R09PE

**SUBJECT: RECALL R09PE VANDAL LOCK STARTER INHIBIT
NONCOMPLIANCE**

Vandal Lock Starter Wiring

MODELS AFFECTED: 2003-2010 All American Rear Engine models with Vandal Lock Options

Screw
Behind Driver's Side Front Access Panel

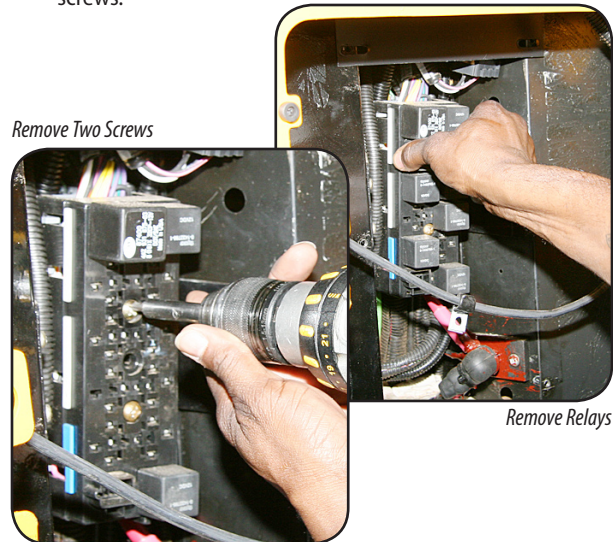
3.1 Remove six fasteners securing the windshield washer hose and the interior access panel.

3.2 Pull out and press down the interior access panel exposing the Master Chassis Harness Relay Box. Note: Panel may be completely removed by removing center screw in lower flange.

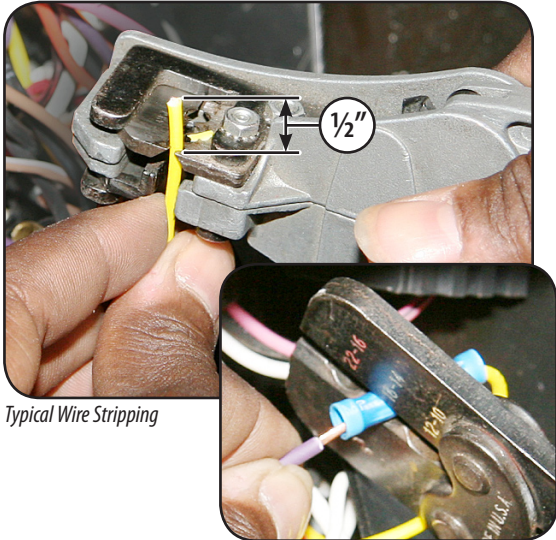
3.5 Locate 16 gauge purple wire 1008, that runs to the IGN dropout relay (4th down on left). Cut wire 1008 and tape the stub wire at the relay.

3.6 Locate 18 gauge yellow wire 1009, that runs to the Vandal Lock Relay (5th down on right). Cut wire 1009 about 4 inches back from the relay.

Typical Wire Splicing

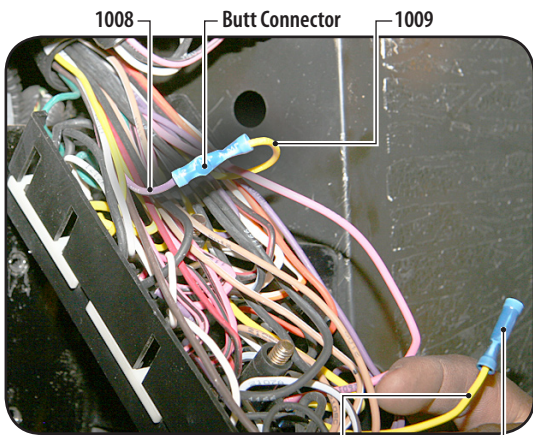
4" Yellow Wire from Vandal Lock Relay Splice to new loomed wire provided.

3.8 Strip the 16 gauge loomed wire provided (BB #01871300) and the 4 inch yellow 18 gauge wire coming from the Vandal Lock Relay (referenced in step 3.6) 1/2 inch from the ends. Splice wires together using butt connector provided (BB #00036507).

Wiring Access to Chassis

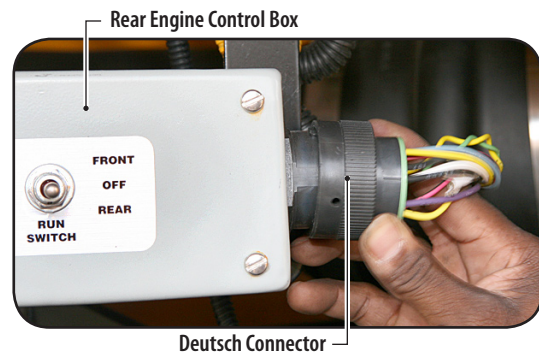
3.9 Pry back insulation material below relay box to create an access to the chassis for routing free end of 14 gauge loomed wire to the rear of the bus.

3.10 Insert free end of loomed wire thru the access created in step 3.9 and feed through the remaining wire.

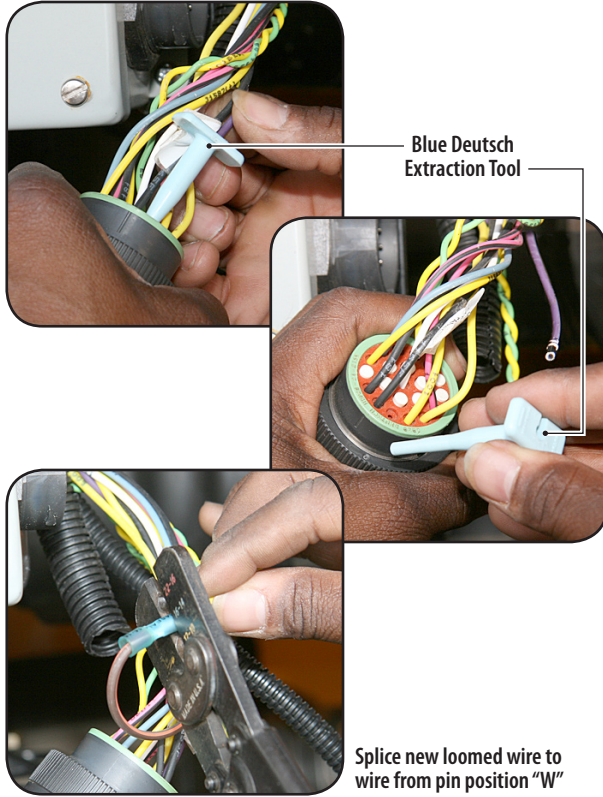
5.1 Remove Deutsch connector from the Rear Engine Control Box. Locate pin positions "X" and "W".

5.2 Remove the wire in pin position "W" using blue Deutsch extraction tool provided with parts. Cut off the terminal and strip wire 1/2 inch from the end. Splice to the new wire that was run through the chassis, using butt connector provided (BB #00036507).

5.3 Remove the wire in pin position "X" and place in pin position "W".
